Arklow Flood Relief Scheme

Report on CPO at Arklow Town Marsh and South Quay

Wicklow County Council

Report No. W3689-W-R002

Figure 7.1 – Location of Plot 124d (circled red)

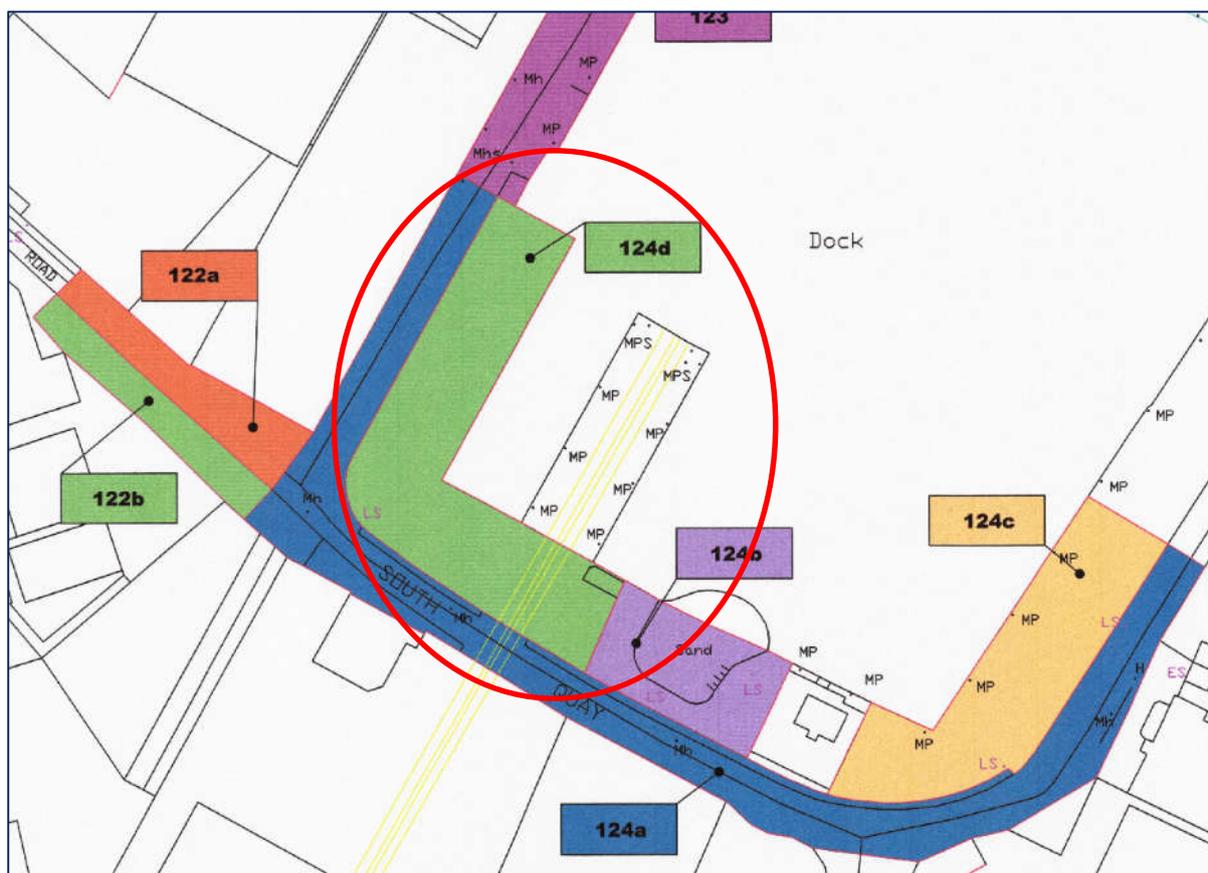
CPO-4 relates to plot 124d shown below in Figure 7.1. The Appellant, Arklow Slipway Limited, raised issues in relation to the proposed acquisition with respect to:

- Denied access to water from plot 124d.
- Potentially denied access to retained lands following sale.

As described in Section 5.3 above, Wicklow County Council is agreeable to changing the acquisition of plot 124b from permanent to temporary. Therefore, there will be no long-term impact on access to the Dock for the Appellant. The proposed development for the FRS provides for the existing access to plot 124d to remain at its current location and demountable flood barriers to be erected at the access, as identified in Drawing No. 88601-1042 in Appendix 4.1 of the EIAR, with extract shown in Figure 7.2 below.

Based on the current use of the plot, this existing access is considered to be sufficient for the Appellant's business. It is noted that there is currently no planning permission in place for another access to this plot.
